FHWA-LA-EIS-01-01-F
STATE PROJECT NO. 700-29-0112
FEDERAL AID PROJECT NO. HP-NH-TO21(002)

LOUISIANA 1 IMPROVEMENTS
GOLDEN MEADOW TO PORT FOURCHON

REVISED RECORD OF DECISION
MARCH 2009

RECORD OF DECISION (REVISED MAY 2004 & MARCH 2009)

LA1 Improvements - Phase 2
Revised Alignment - Leeville to Golden Meadow

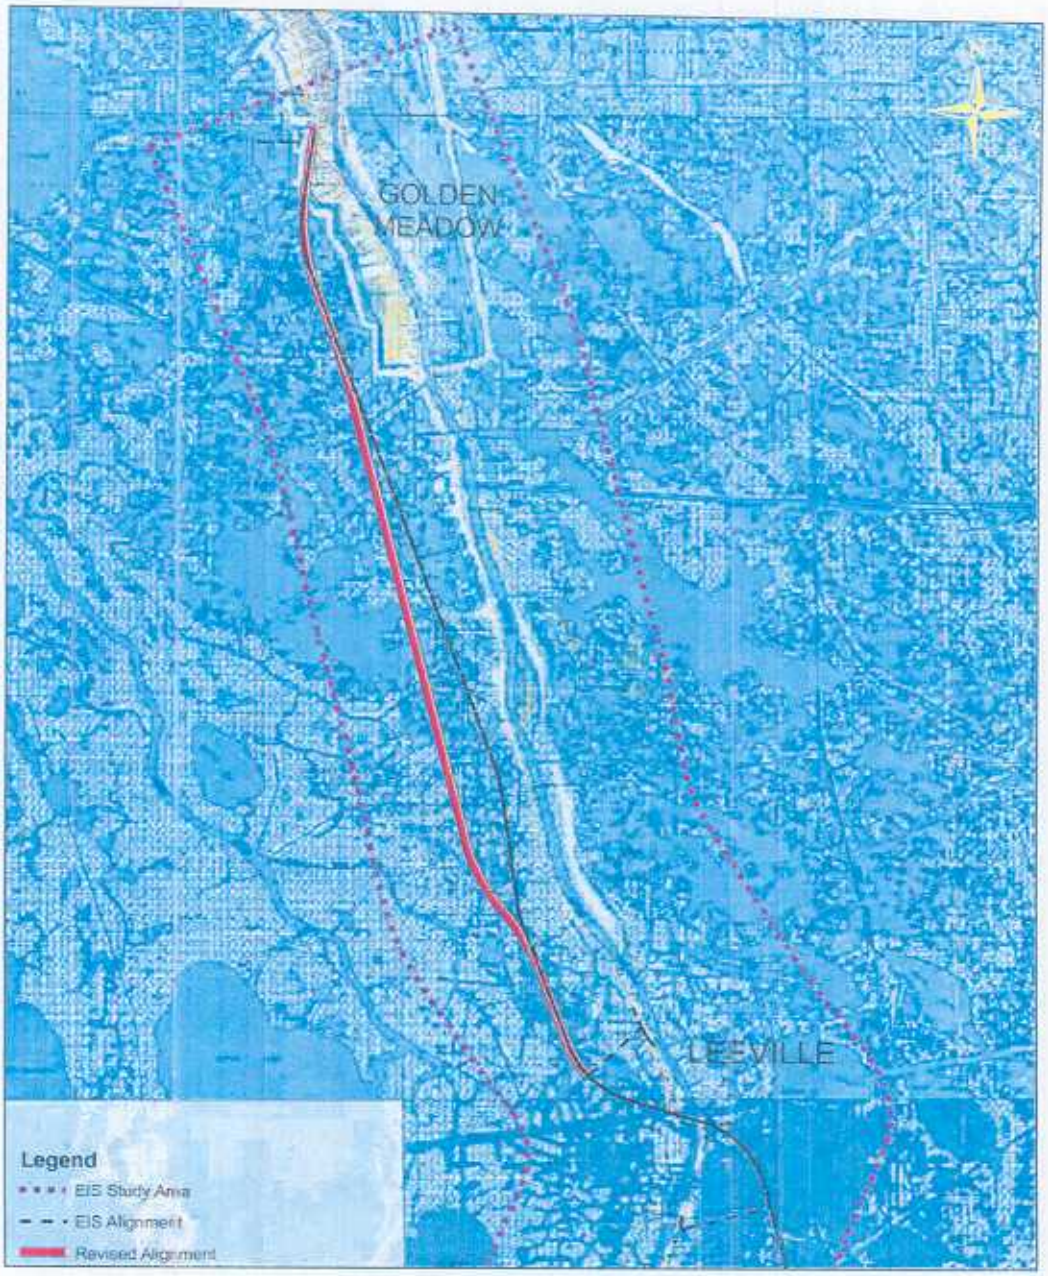
revision to the ROD. Three existing transmission pipelines would require over 1000 ft. of pipe relocation. Pipeline relocations would be costly, impact existing coastal marsh and would be potentially harmful to the environment. It was determined that the alignment should be relocated approximately 1200 ft. westward to avoid conflicts with the pipelines in this location. In addition to eliminating these pipeline relocations, the shift reduces the number of pipeline crossings. For comparison purposes, the attached exhibit in the appendix entitled, "LA1 Improvements-Phase 2, Revised Alignment-Leeville to Golden Meadow" shows both the original alignment and the shifted alignment.

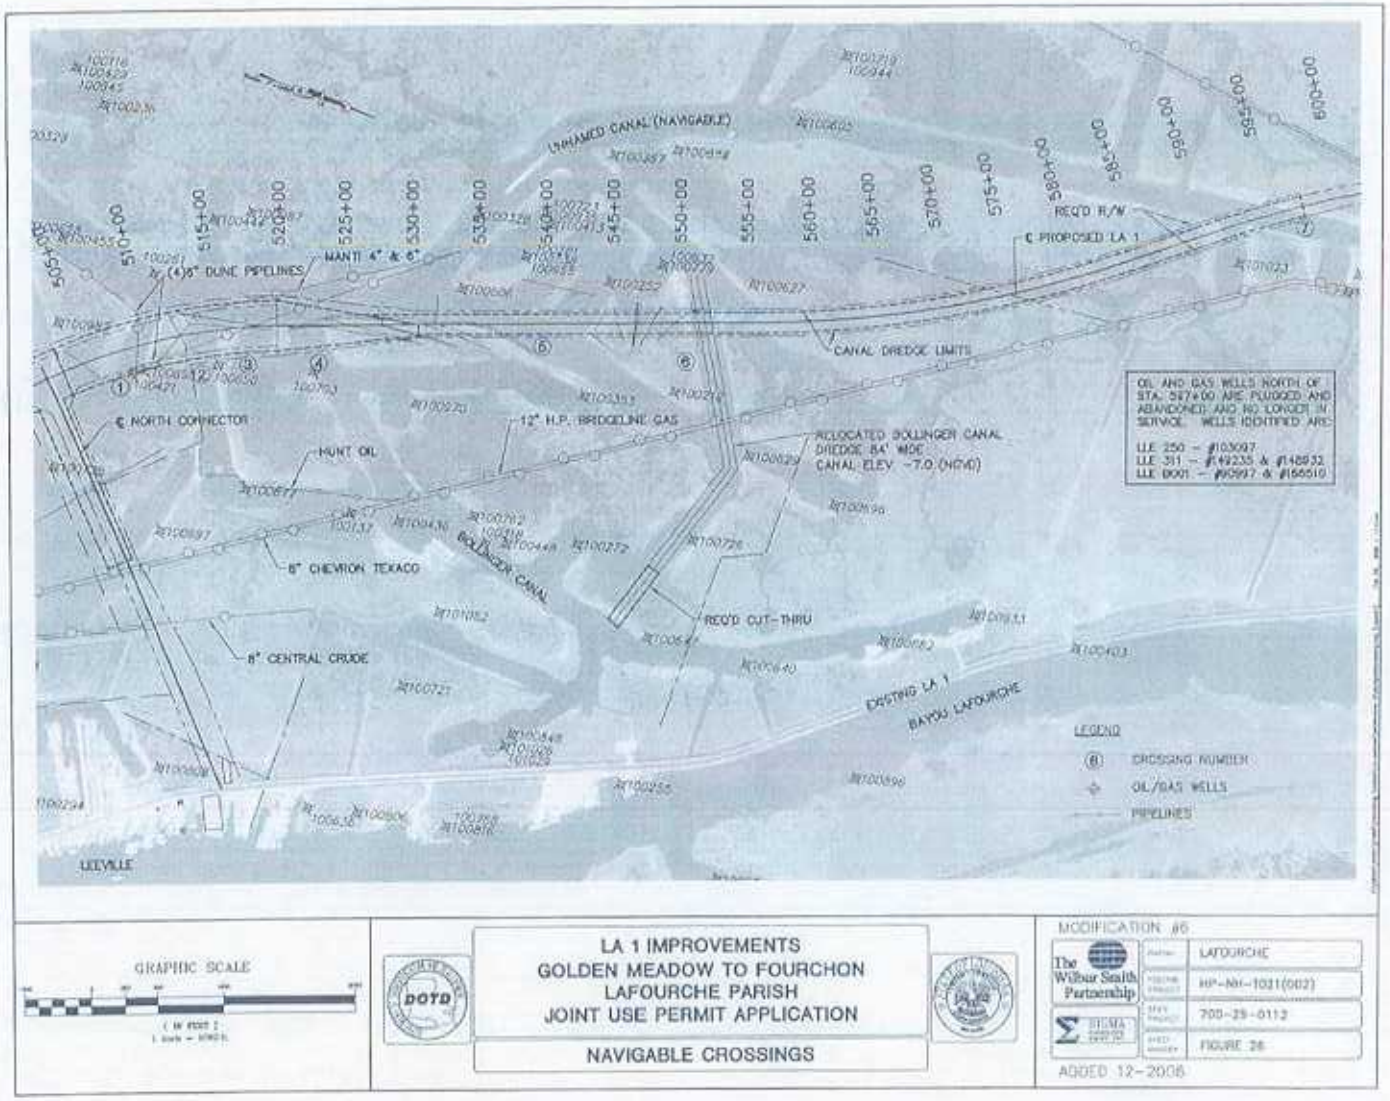
An alternative crossing location has been identified that would require minor dredging in order to maintain existing accessibility to the oil and gas facilities. The relocated Bollinger Canal will have a 55' vertical clearance and 65' minimum horizontal clearance. Both the US Coast Guard (USCG) and the landowner agreed with the alternative crossing location. All existing canals could potentially be accessed with this layout. Attached hereto in the appendix is "Figure 26" from the permit application which shows the location of the alternative crossing and its relationship to the canals in the area. The clearances for the other seven canals will be determined in the final design of Phase 2. All seven crossings were discussed with the USCG who requested that the crossings be identified and included in the future USCG permit, as an approved span arrangement has not yet been determined. Several wells were identified as having access from canal 7. Although access to these wells will be impacted by the construction of the project, the wells all appear to be plugged and no longer serviceable.

investigate a canal crossing to this field that would provide 55' of clearance, the same clearance that was negotiated in Phase 1. It was explained that due to the north connector being located so close to the Bollinger Canal, the 55' clearance cannot be obtained at the existing location of Bollinger Canal. Therefore, the project team proposed dredging and extending one of the other canals in the area to maintain access to the area. The proposed location for 55' clearance is labeled Canal "6" on the figure in the appendix.

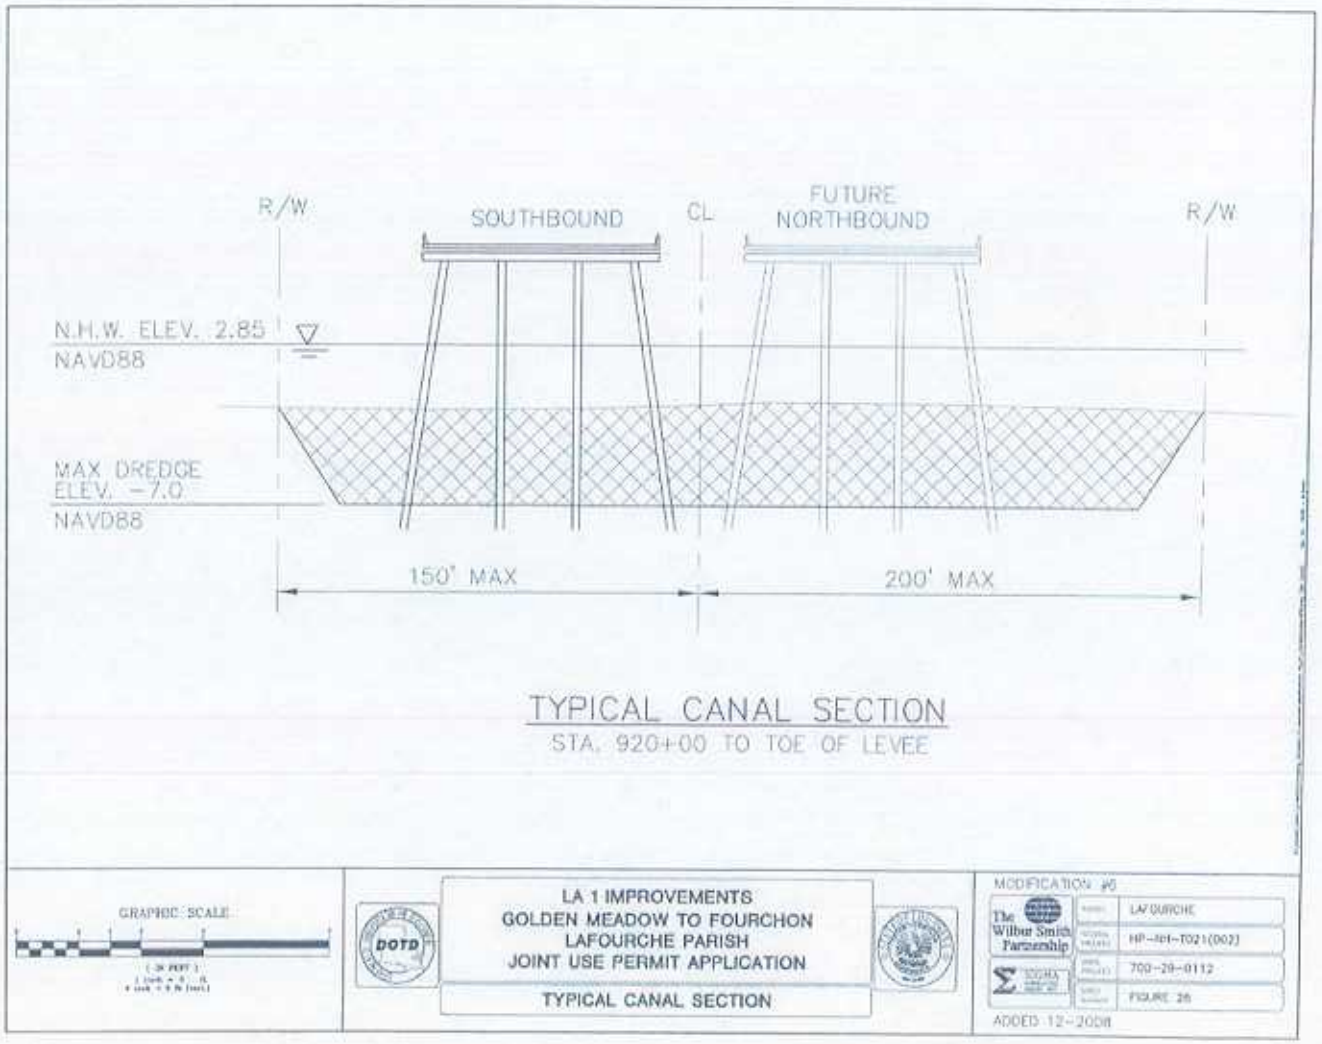
In order to facilitate construction of the Bollinger Canal navigable crossing, additional dredging is necessary. It is DOTD's responsibility to relocate and dredge the canal as part of the project. Dredging limits will be extended from Sta. 530+00 to Sta. 597+00 for a standard 150' width and a bottom elevation of -7.0 NGVD. The anticipated dredge quantity for this activity is 186,100 yd^3 over 23.1 acres. Also, to facilitate high level bridge construction near the Golden Meadow Hurricane Protection Levee, dredging limits between Sta. 920+00 to Sta. 928+00± (toe of levee) will be added. This canal will have a 350' max width with a bottom elevation of -7.0' NGVD. The anticipated dredge quantity for this activity is 93,300 yd^3 over 6.4 acres. Also, to maintain marine access to the oil and gas facilities, Relocated Bollinger Canal will require 45,100 yd^3 of dredging over 5.6 acres. The total dredge quantity for this project will be increased by 324,500 yd^3 from 948,000 yd^3 to 1,272,500 yd^3. The additional 324,500 yd^3 of excavation includes 122,600 yd^3 over 15.2 acres of non-vegetative water bottoms and 201,900 yd^3 over 19.9 acres of wetlands. Note that quantities of excavation between Sta. 503+00 to Sta. 530+00 were accounted for in the original permit. Beneficial use of dredge material is expected and will be addressed in the mitigation plan for this project.

POTENTIAL FILL AREA SCHEMATIC

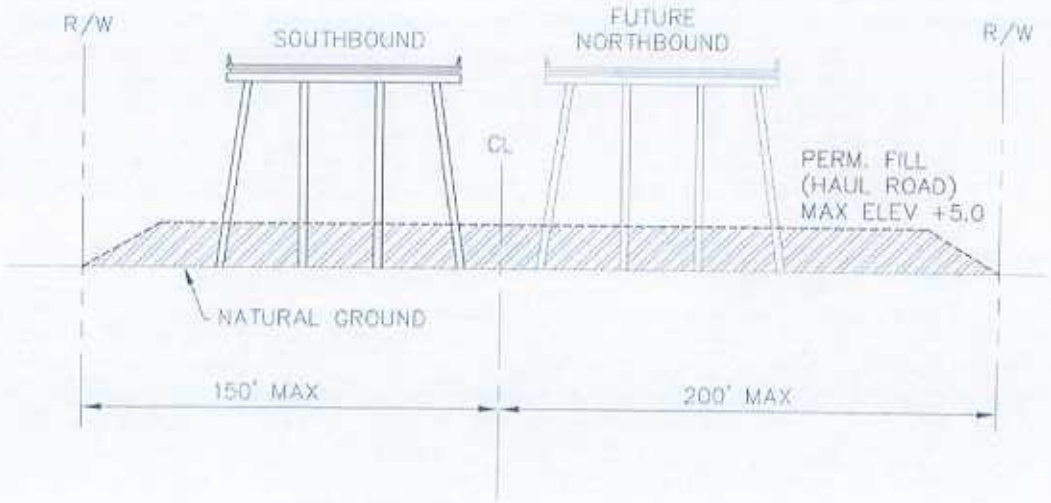
Based on this information, the design team is recommending steel spans crossing the levee structure with a pier in the levee crown. The pier will also serve as a flood protection wall to accommodate the COE and South Lafourche Levee District's flood protection needs. The entire superstructure of the bridge will be above the anticipated +25.5 ft elevation. Also, in order to facilitate construction of the high level crossing of the levee, either construction canals or a haul road is anticipated. Several figures in the appendix depict the impact of either option, the construction of canals or a haul road. The first figure is sheet 18 from the permit application and is entitled, "LA 1 Mainline – Plan Profile." This sheet shows the plan and profile for both options at the levee. The next sheets, Figures 28 and 29 from the permit application, show typical cross sections. Figure 28 is entitled, "Typical Canal Section" and depicts the cross section for the dredge option. Figure 29 is entitled, "Potential Fill Area Schematic" and depicts the cross section for the haul road option.

In order to allow the contractor to determine the most cost efficient method of construction, a haul road could be also anticipated between Sta. 920+00 and Sta. 928+00± (toe of levee) near the Golden Meadow Hurricane Protection Levee. The haul road is being permitted as permanent fill to elevation +5.0 NGVD in order to provide protection to the existing levee and also serve as a wave berm. The anticipated permanent fill quantity for the haul road is 31,000 yd^3. This will increase the total project permanent fill from 51,000 yd^3 to 82,000 yd^3. The total fill quantity for this project will be increased from 386,000 yd^3 to 417,000 yd^3.

LA1 Improvements - Phase 2
Construction Type Map

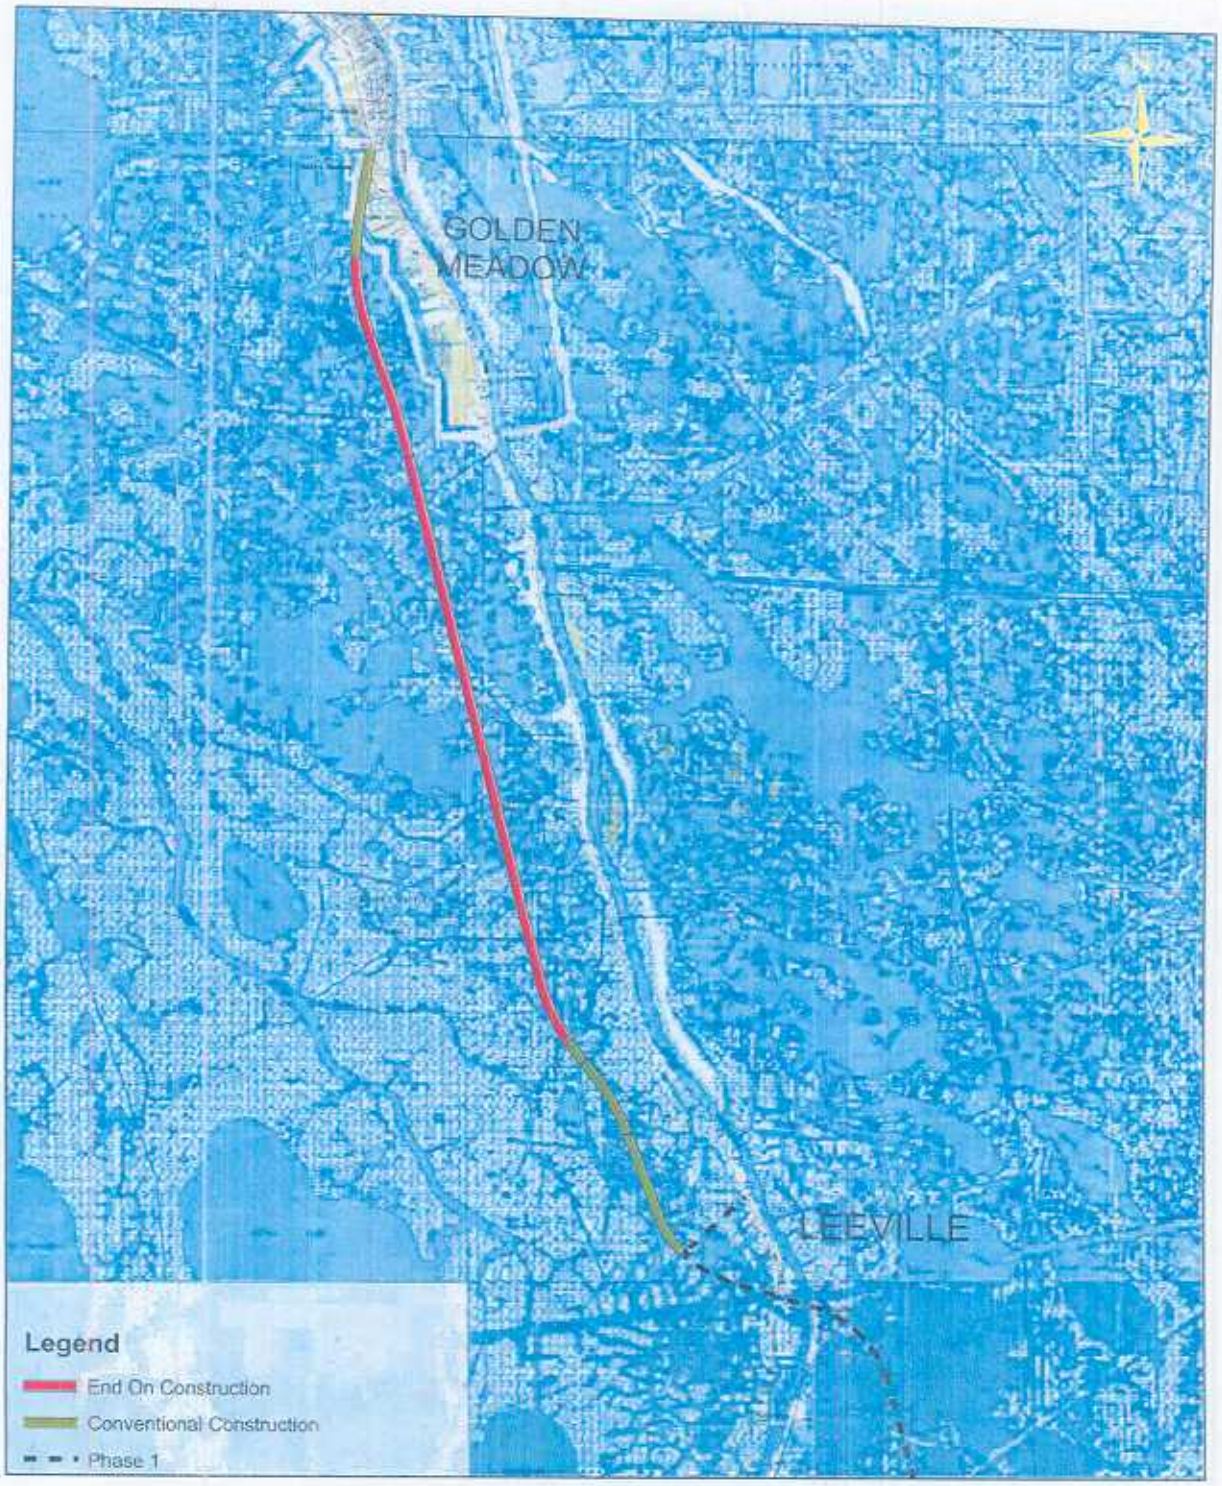
The original commitment to use end on construction remains. A large portion of Phase 2 will be constructed using this technique. Top down is being projected from Sta. 597+00 to Sta. 920+00. Conventional construction from Sta. 503+00 to Sta. 597+00 and then Sta. 920+00 to Sta. 961+18. The attached exhibit in the appendix entitled, "LA1 Improvements-Phase 2, Construction Type Map" depicts the extent of end on construction planned in this phase.
